# Technical Information Bulletin

## Concerning: Modification of the Slimline cabinet softener & MMX

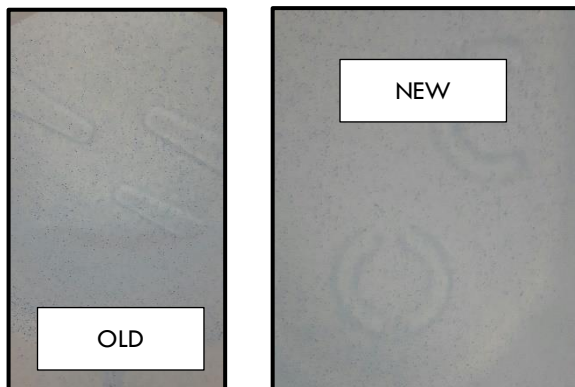
- Better finish
- Smaller opening at the back of the cabinet

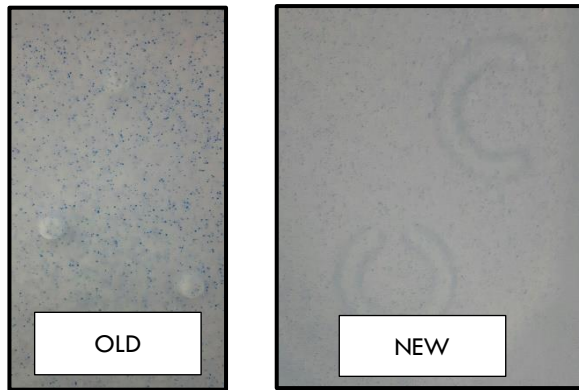
- Other height for the maxi cabinet, from 963 to 965 mm with brine well PN BW3.5/090.
- Improvement of the fixation of the bottom of the tank:

- Better fixation of the brine well:
